Safety Evaluation Report

With Open Items Related to the License Renewal of
Prairie Island Nuclear Generating Plant
Units 1 and 2

Docket Nos. 50-282 and 50-306

United States Nuclear Regulatory Commission

Figure 4.3-1

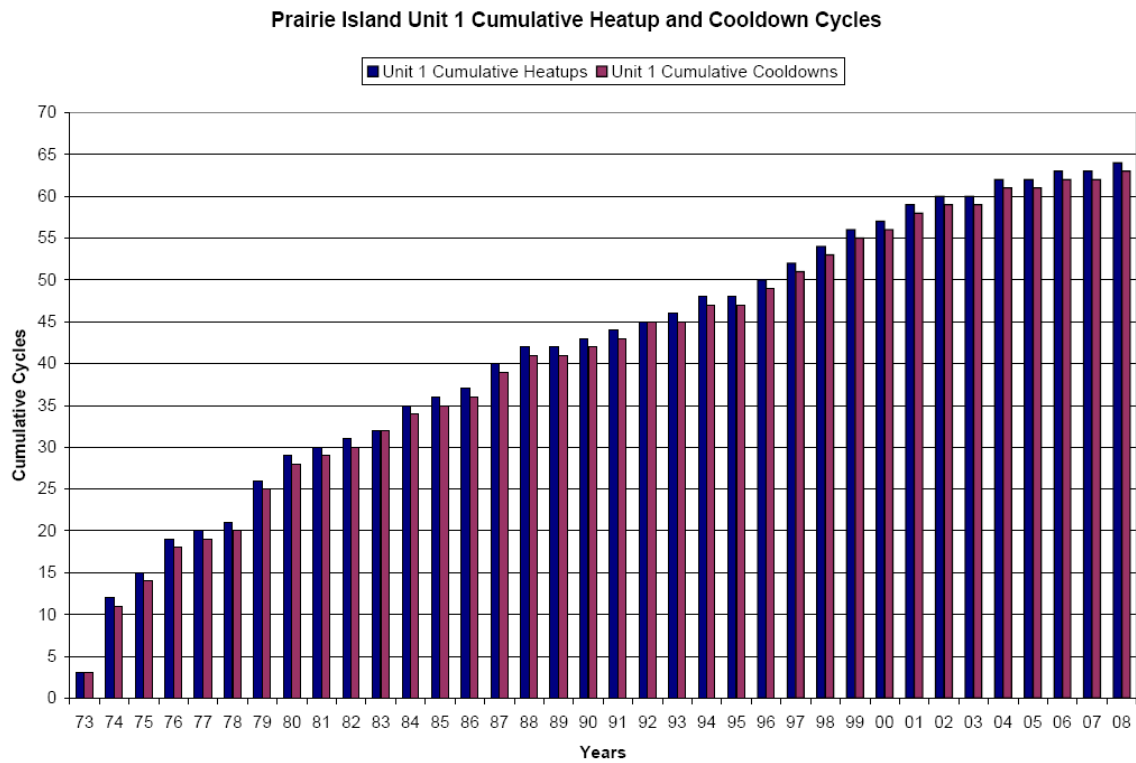
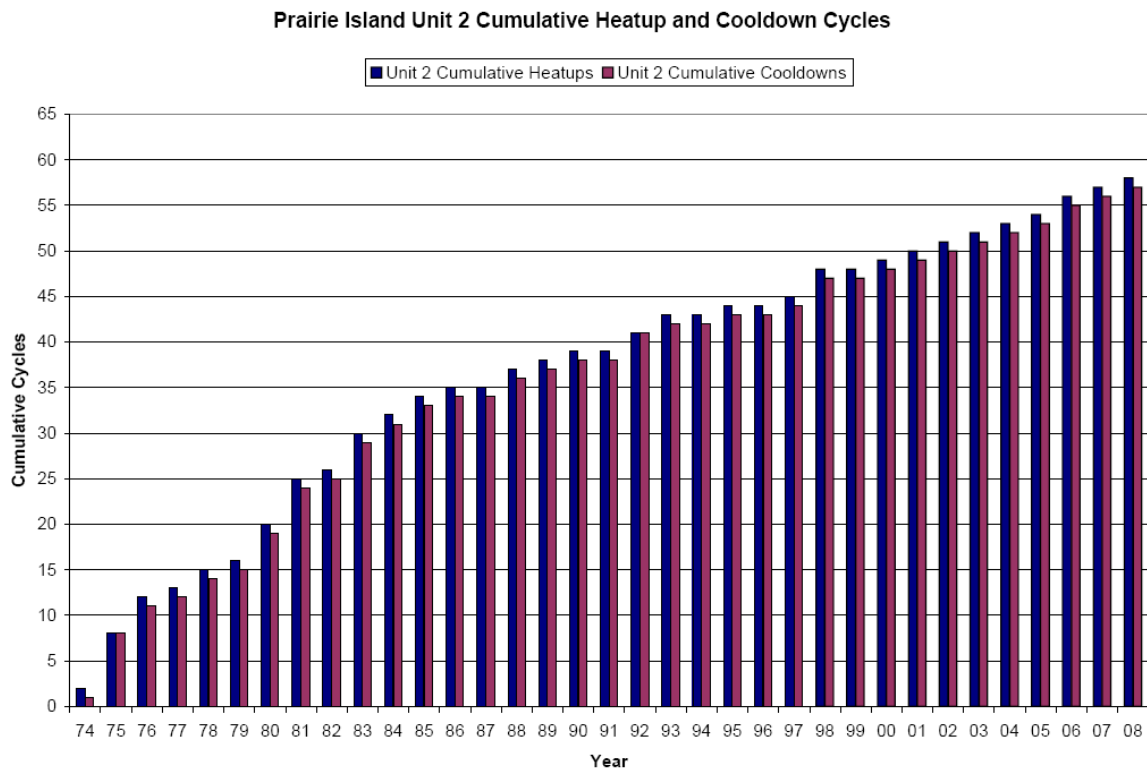
The staff reviewed these histograms and found that the transient occurrence rates (both heatup and cooldown) are quite constant for Unit 1 since 1980 and for Unit 2 since 1983. This means that for the past 25 years, the PINGP (Units 1 and 2) plant operation has been quite steady. The applicant made its cycle projections based on the slope of a straight line connecting the time of the plant startup (1973 for Unit 1 and 1974 for Unit 2) and the last data point, 2008. It is clear from Figures 4.3-1 and 4.3-2, that the slope used by the applicant for making cycle projections is significantly greater than that of the average of the past 25 years. As expected, the slopes of event occurrence (i.e., the rates) during the first few years (5 to 7 years) are higher than the averages for both heatups and cooldowns. This means that the basis of projections that the applicant used is conservative and therefore, the staff found it to be acceptable.

Based on its review, the staff's concern on the transient event monitoring is resolved because the applicant provided the information requested and the information validates the PINGP fatigue management program and the applicant's assumption for the number and severity of transients.
